**Re: Response to Request for Further Information
Planning Permit Application No. PA2403200
23-47 VILLIERS STREET, NORTH MELBOURNE**

RESPONSE TO REQUEST FOR FURTHER INFORMATION

Figure 1: City North Structure Plan Figure 3.7 page 41 <https://mvga-prod-files.s3.ap-southeast-4.amazonaws.com/public/2024-04/city-north-structure-plan-2012.pdf>.

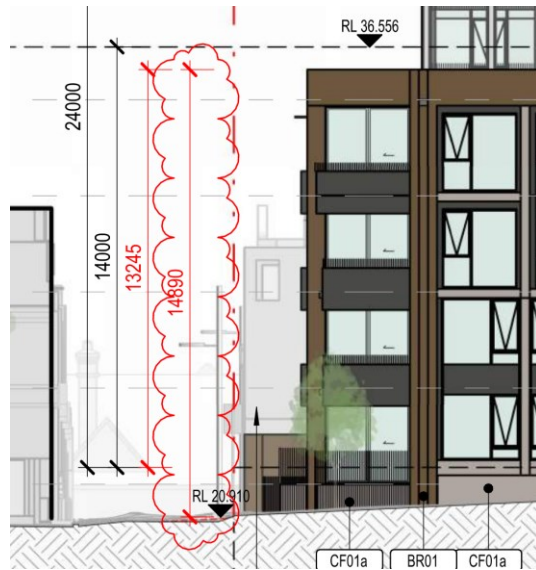
development should be guided by the DDO61 discretionary metrics. We can observe that City North Structure Plan - Figure 3.7 - page 41.

The reality on the ground is an array of constructed and pending developments directly adjacent to the subject site that don't align with the discretionary design guidance of the DDO. Therefore, consideration of the established urban context is fundamentally relevant to the development context. Arbitrary application of height and setback guidance to the measure without due consideration of the existing urban context is a fraught exercise. It lacks contextual understanding and relevance to the established urban character, and often stymies design ingenuity and excellence.

The approach adopted with the proposed development is one that is highly resolved in the sense of assessing and addressing existing character elements and providing a design response that is commensurate to the existing urban context and that is 'integrated' with the existing urban fabric.

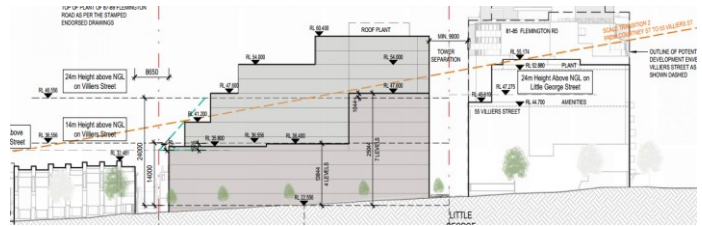
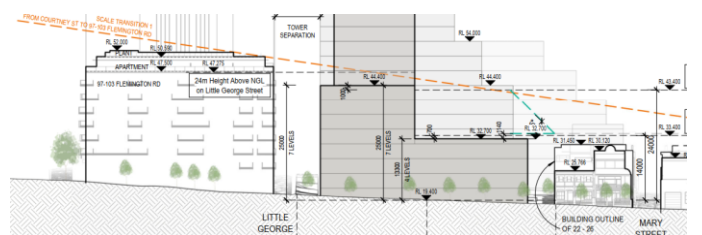
The concerns regarding height and transition focus on the southeast frontage to Villiers Street, the north-west frontage to Harcourt Street, as well as the central form to Little George Street.

At the northeast corner to Villers Street and Little George Street, development is contemplated to a height of 24m under DDO61, whereas the design sits slightly above that by approximately 1.0m. This interface responds to the existing context of 55 Villiers to the northeast, which sits at a comparable height before transitioning approximately 2-3 levels higher shortly thereafter.

The strength of this corner frontage is important design element in terms of appropriately framing the corner location and emphasising this juncture as a critical sense of address for the development.

In relation to Harcourt Street, 14m remains the preferred design guidance under the DDO61. Approximately 60% of the façade adopts a height that is below the 14m level, thereafter firming at the northwest corner frontage to the taller scale of 25m, where 24m is contemplated along the Little George Street frontage under the DDO61.
